Conceptual Review Agenda

February 11, 2008

STAFF PROJECT REVIEW

Staff has reviewed your submittal for **KING SOOPERS, NORTH COLLEGE AND WILLOX - PRELIMINARY DESIGN REVIEW**, and we offer the following comments:

**NORTH COLLEGE AVE.
 & WILLOW LANE
 RETAIL CENTER
 FORT COLLINS, COLORADO
 CONCEPTUAL SITE PLAN**

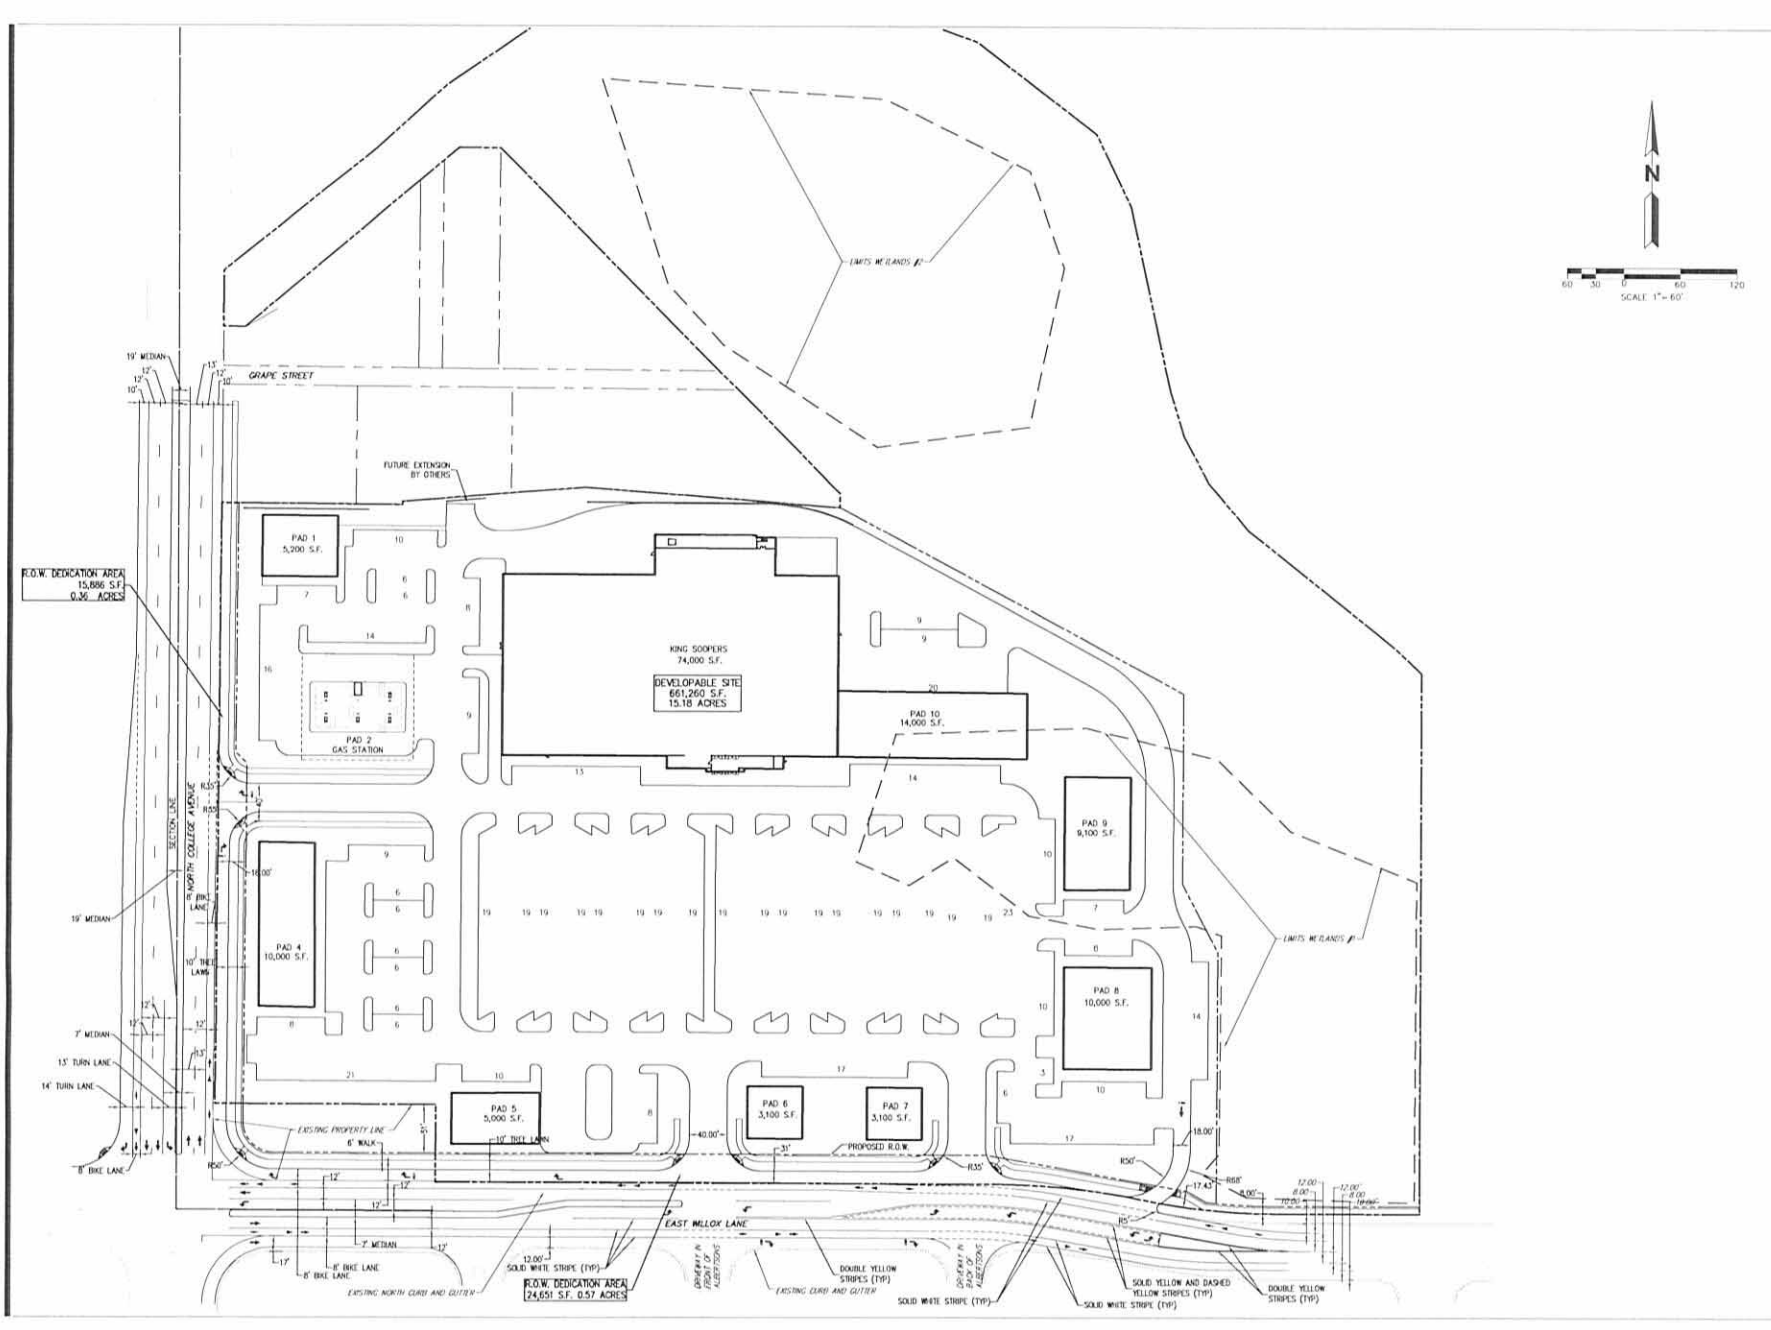
7. A conceptual site plan has been submitted with this meeting request. Only the King Soopers and gas station is currently being designed. Can we submit building elevations for these two (2) units and all the remaining pads be "future" and then be submitted with a separate FDP?

[8/17/06] The site plan presented doesn't include much detail, so additional comments regarding site layout will be made at such time as a more detailed plan is presented.

**NORTH COLLEGE AVE.
 & WILLOX LANE
 RETAIL CENTER
 FORT COLLINS, COLORADO
 INTERSECTION PLAN**

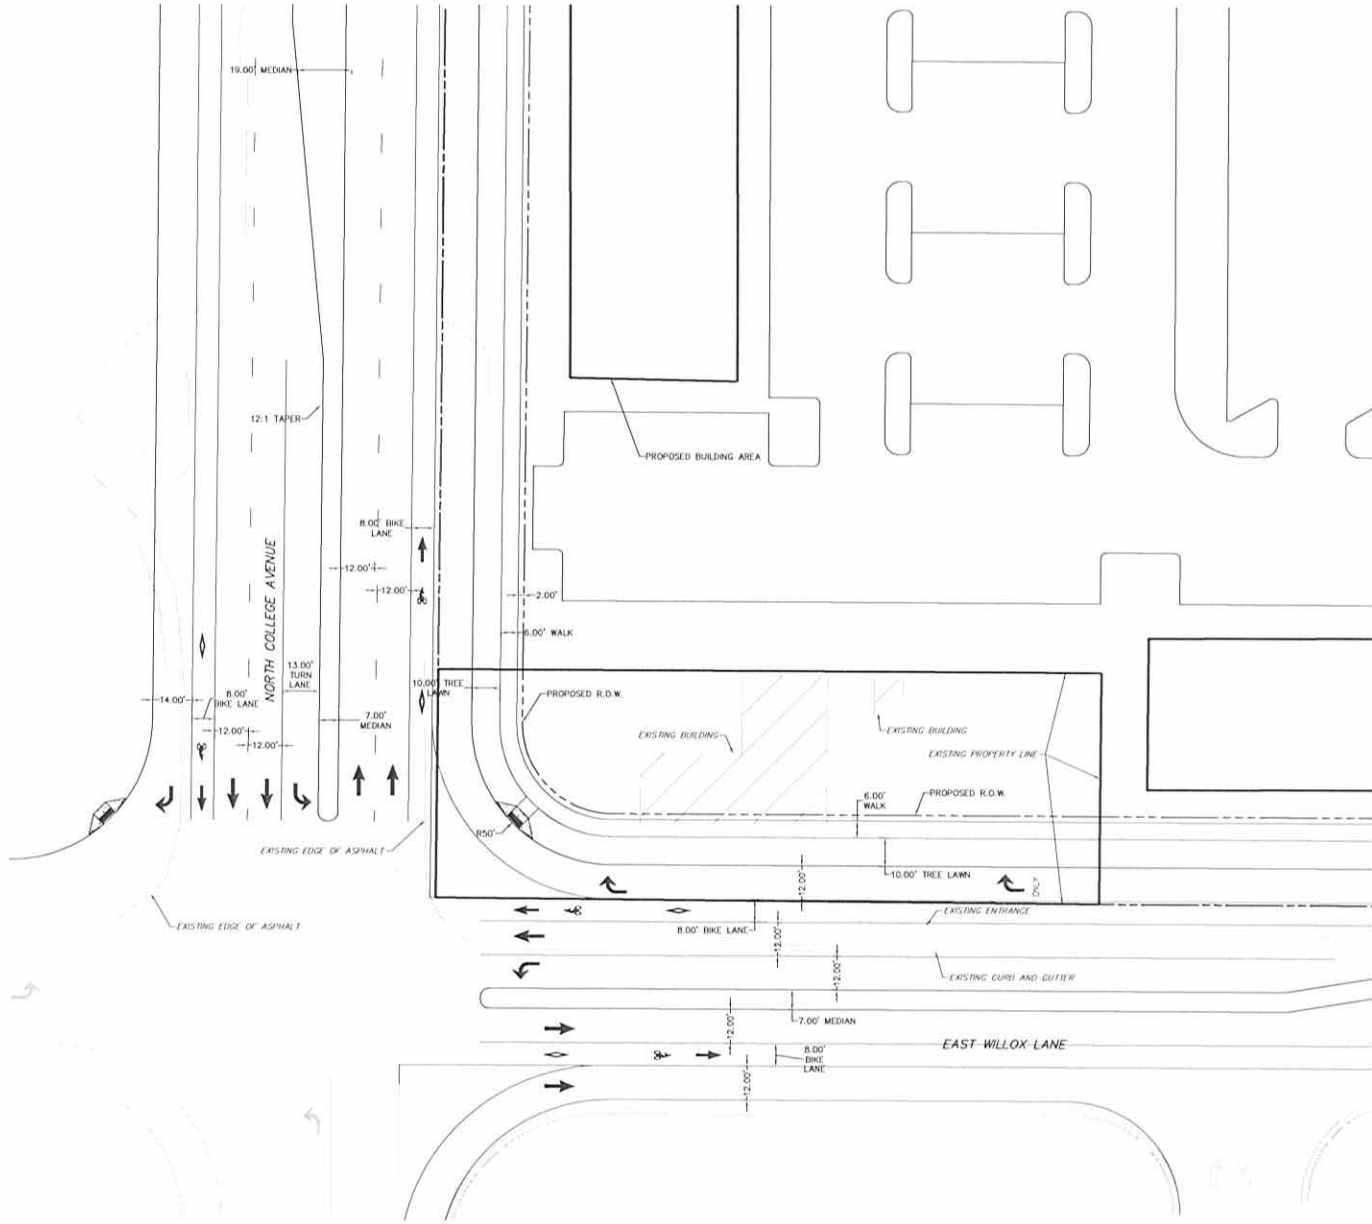
4. A formal traffic study has been submitted to the City by Delich Associates. What is the current approval status of this report?
5. Sheets 2 and 3 of our conceptual submittal include proposed adjacent roadway layout, intersection layout and roadways overlaid over an aerial photo all based upon the traffic report. We would request that the City's provide conceptual approval or comments regarding our interpretation of the report.

[8/25/06] The City will take the lead as Project Manager for the College / Willox intersection improvements and the improvements will be considered a Capital Project.

[8/25/06] Per the City's adopted standards, a roundabout design analysis will need to be completed.

[8/25/06] The intersection design will be subject to the review and approval of the Colorado Department of Transportation (CDOT).
